# CITY OF ALBUQUERQUE

**RE: 8737 Central Ave NW**  
**Grading and Drainage Plan**  
**Engineer's Stamp Date: 2/25/25**  
**Hydrology File: K09D053**  
**Case # HYDR-2025-00063**

SERRANO, DANIEL (M. TRUJILLO, ARCH) - GRADING & DRAINAGE PLAN

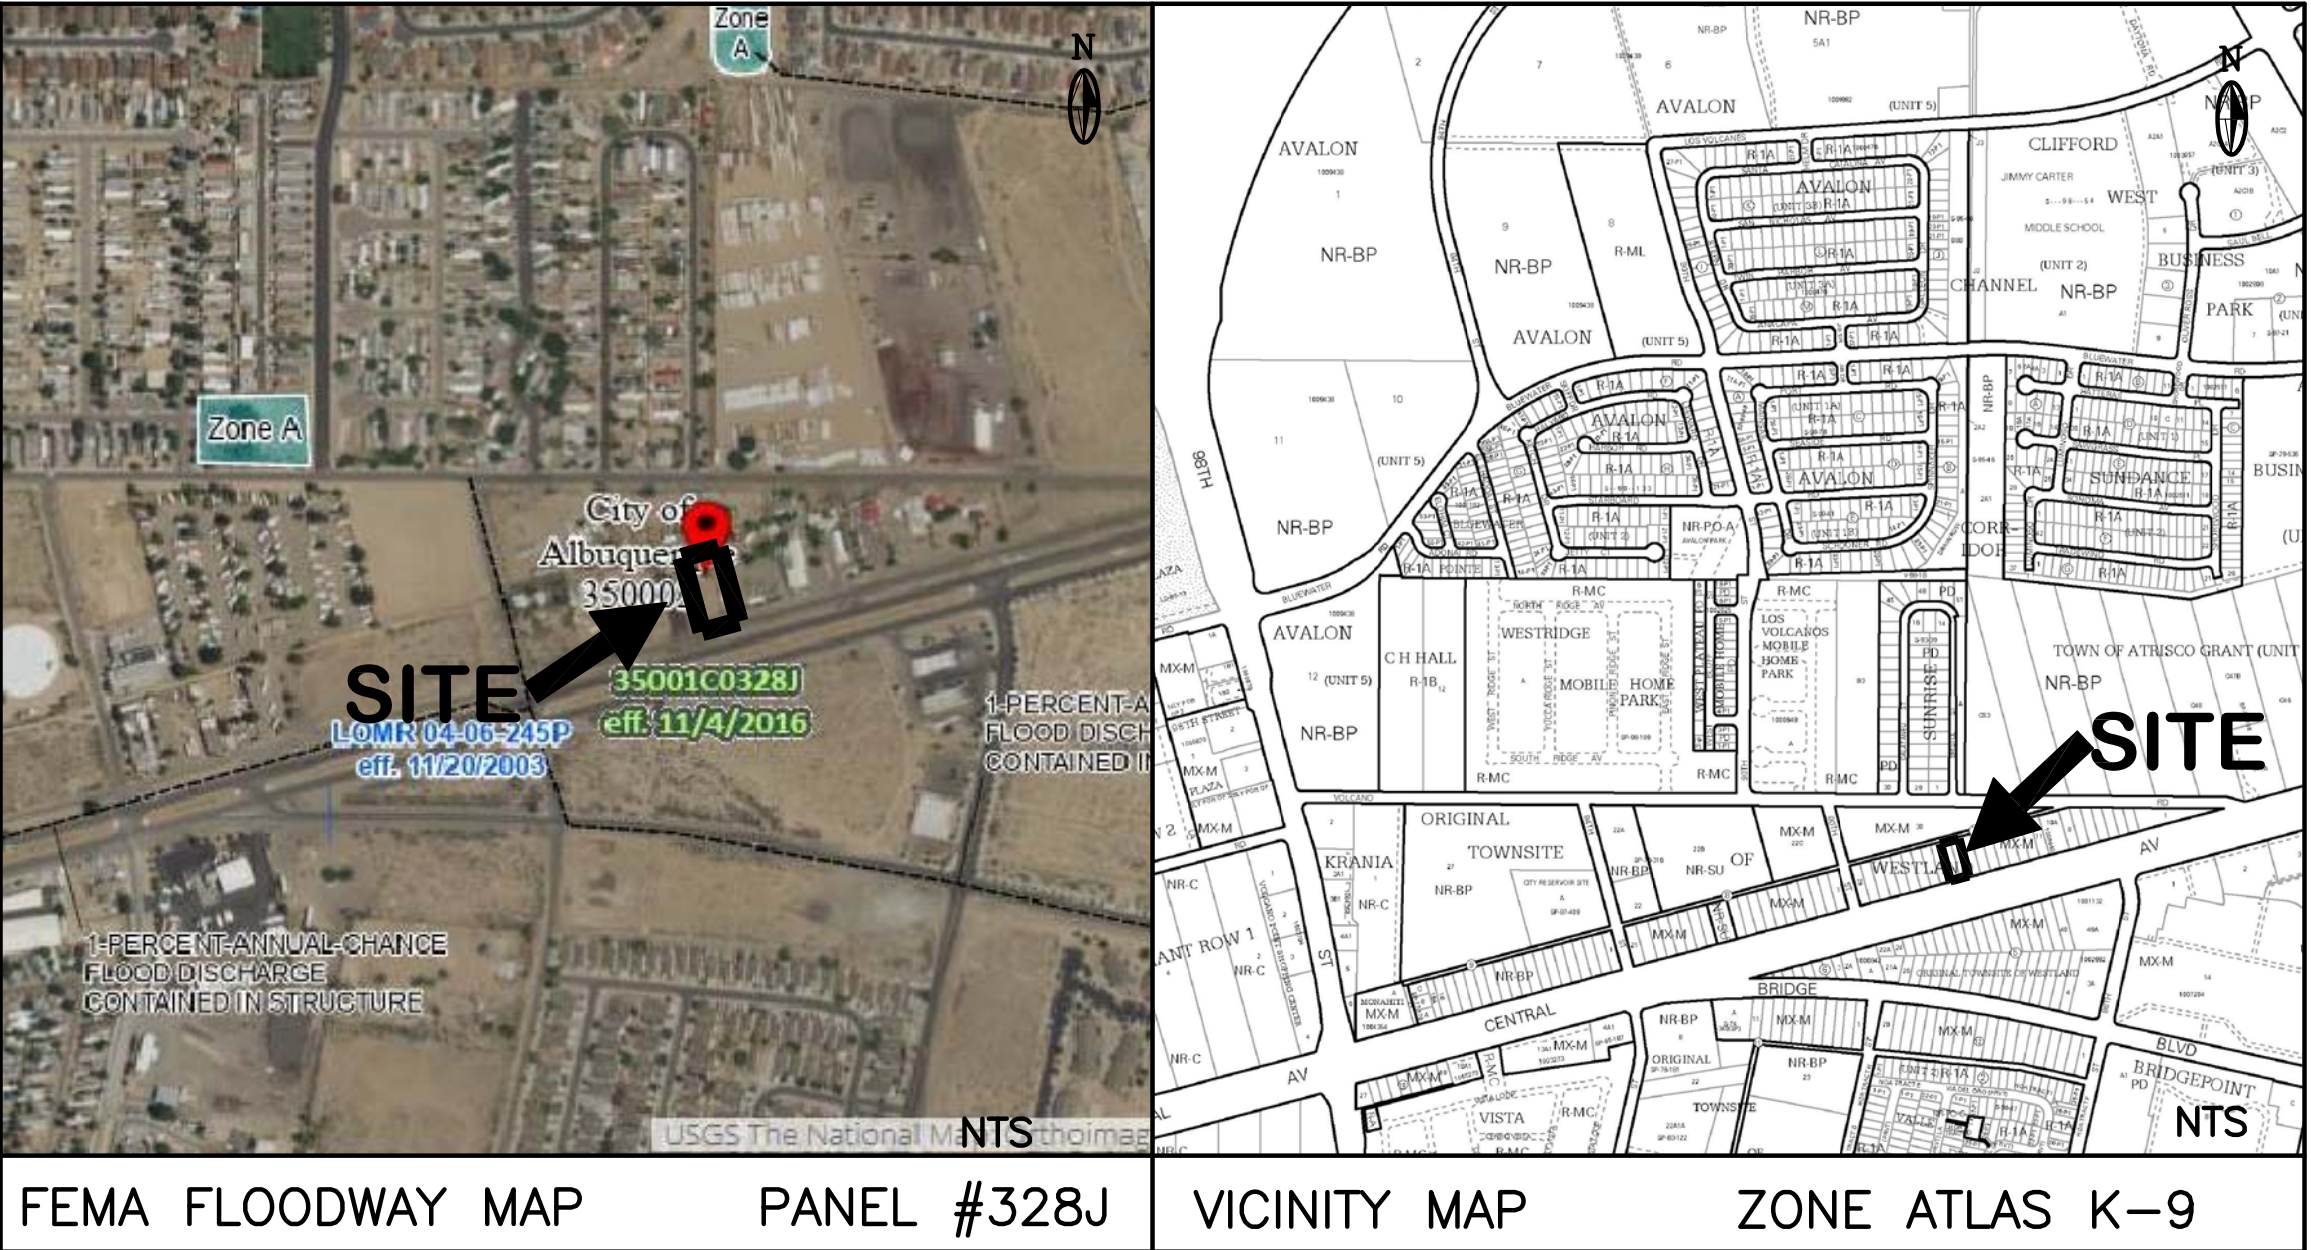
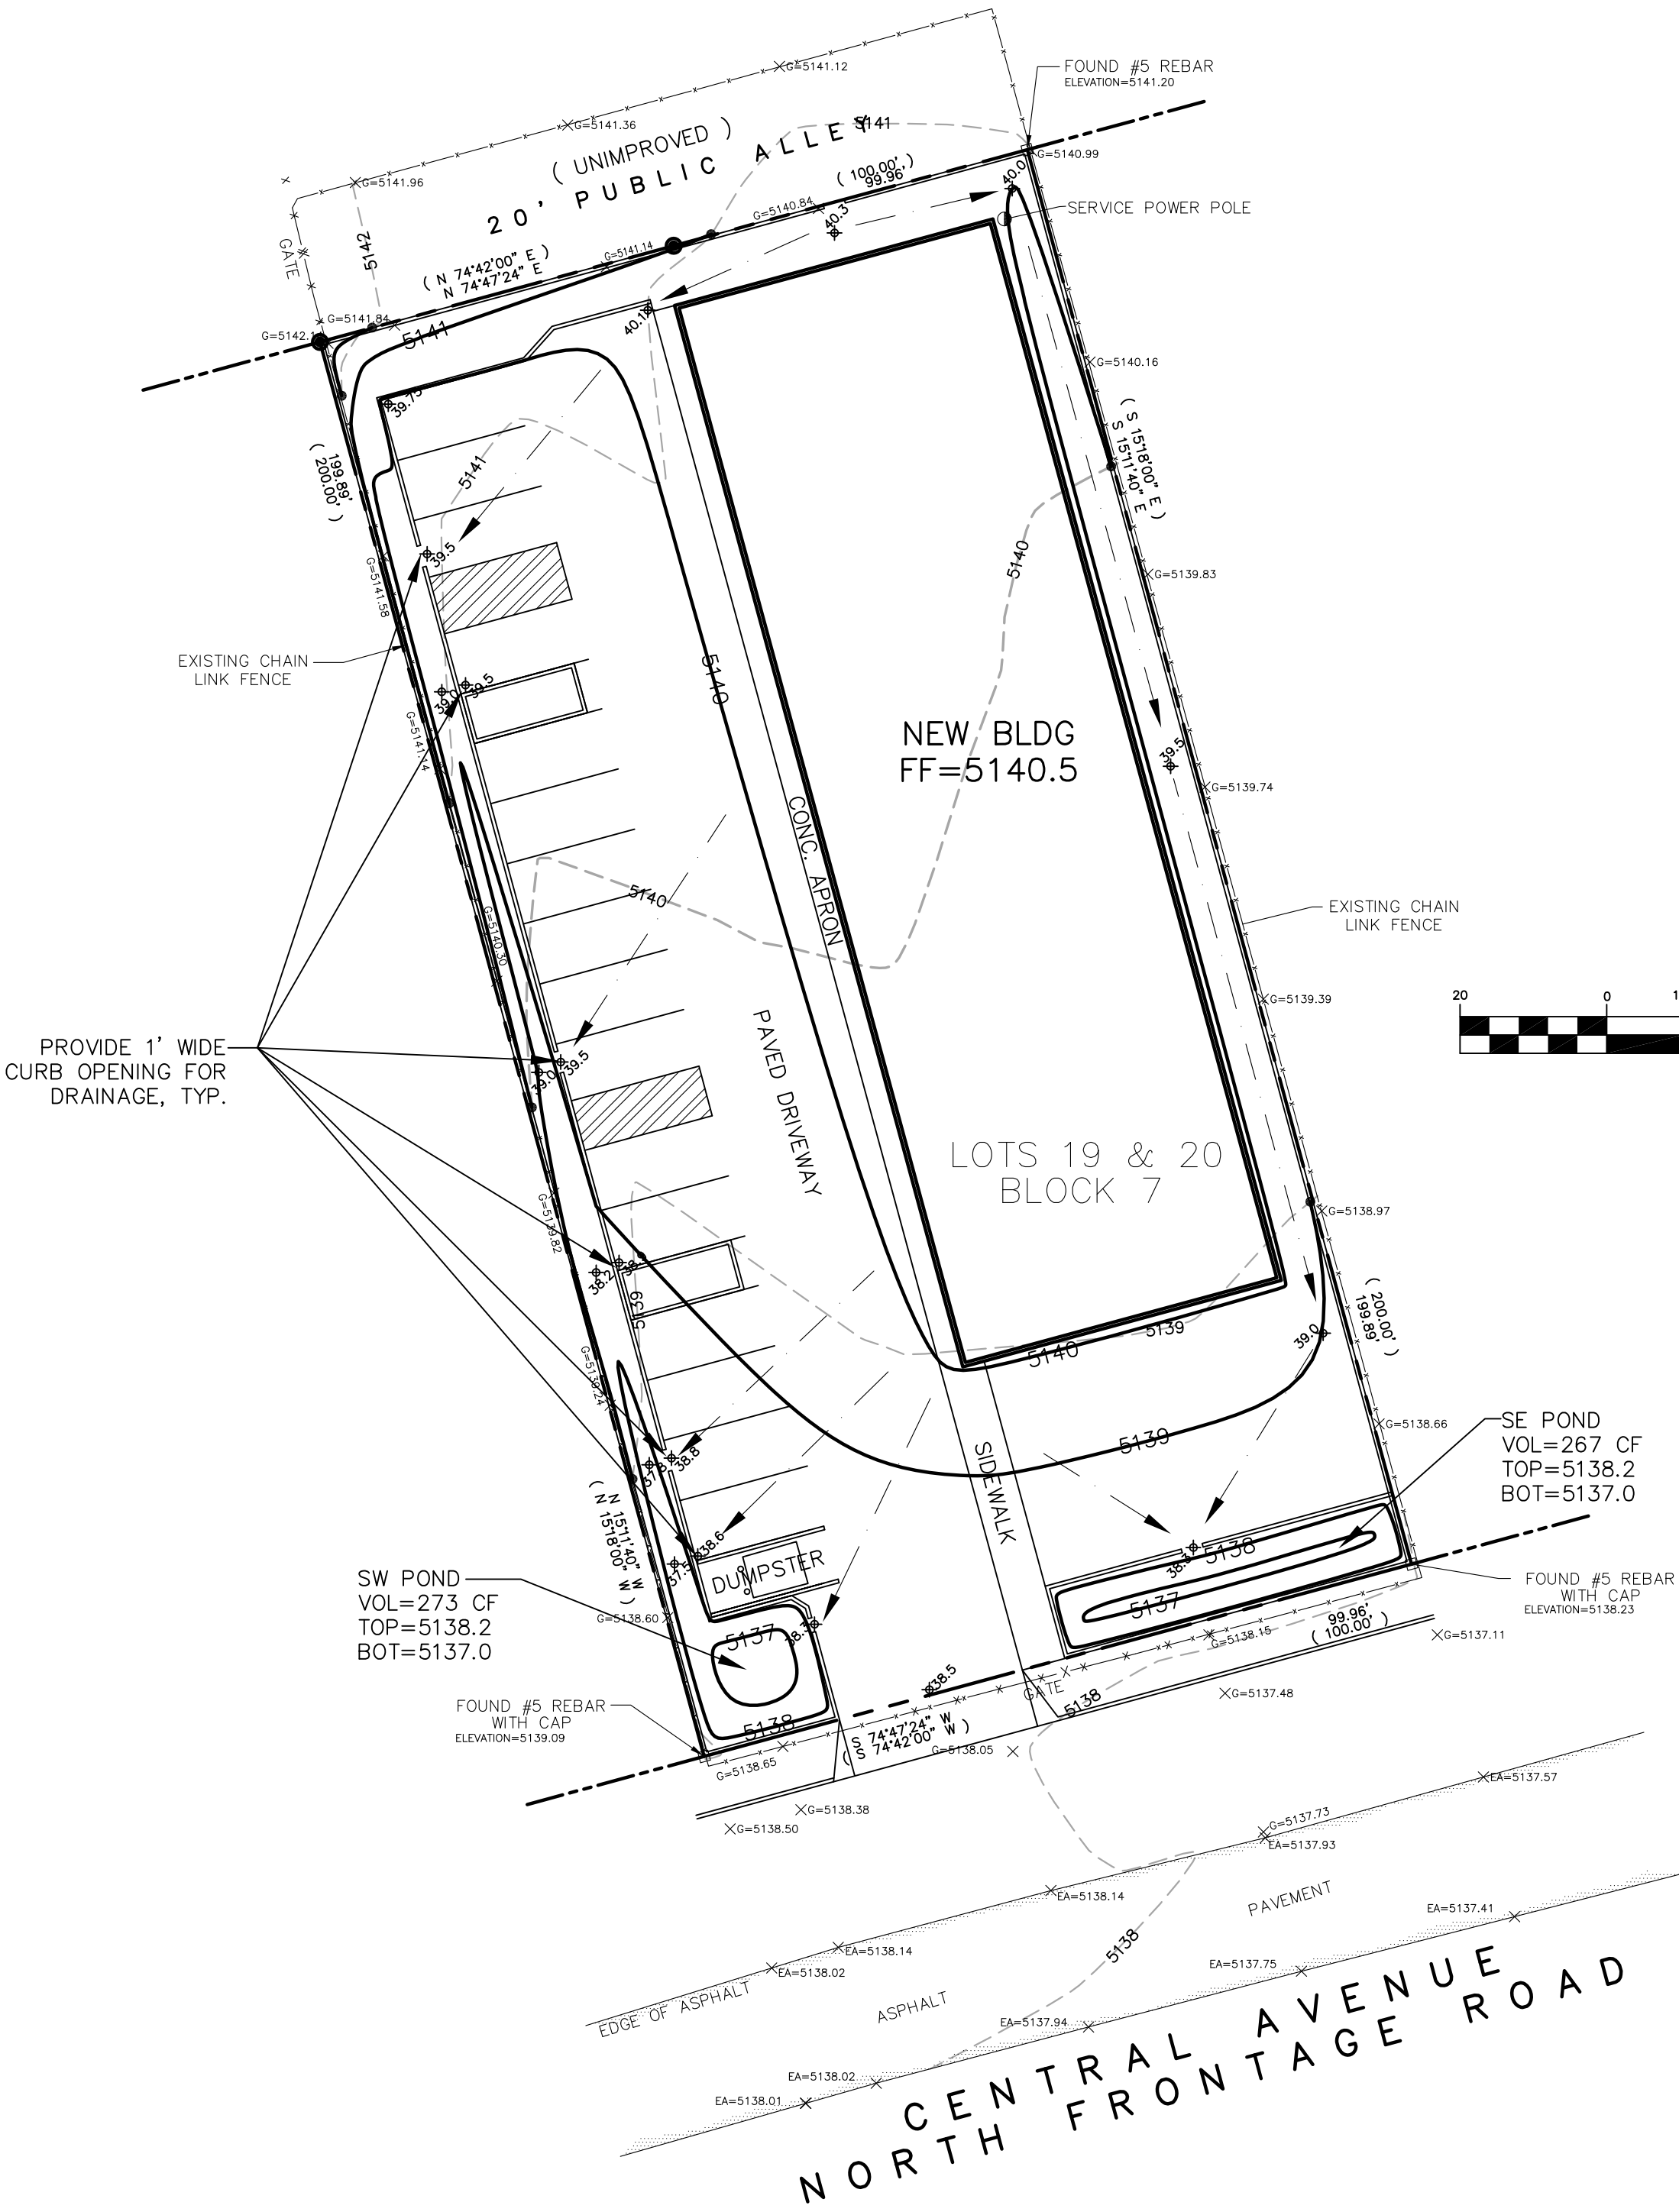
Based upon the information provided in your submittal received 02/26/2025, the Grading & Drainage Plan is approved for Grading Permit, Building Permit and for action by the DHO/DFT on Platting. Please attach a copy of this approved plan in the construction sets for Building Permit processing along with a copy of this letter.

1. Engineer's Certification, per the DPM Part 6-14 (F): *Engineer's Certification Checklist For Non-Subdivision* is required.
2. Please provide the executed paper Drainage Covenant (latest revision) printed on one-side only with Exhibit A and a check for **\$25.00** made out to "**Bernalillo County**" for the stormwater quality ponds per Article 6-15(C) of the DPM to Hydrology for review at Plaza de Sol. The Covenant and Exhibit will also need to be uploaded to ABQ-PLAN.
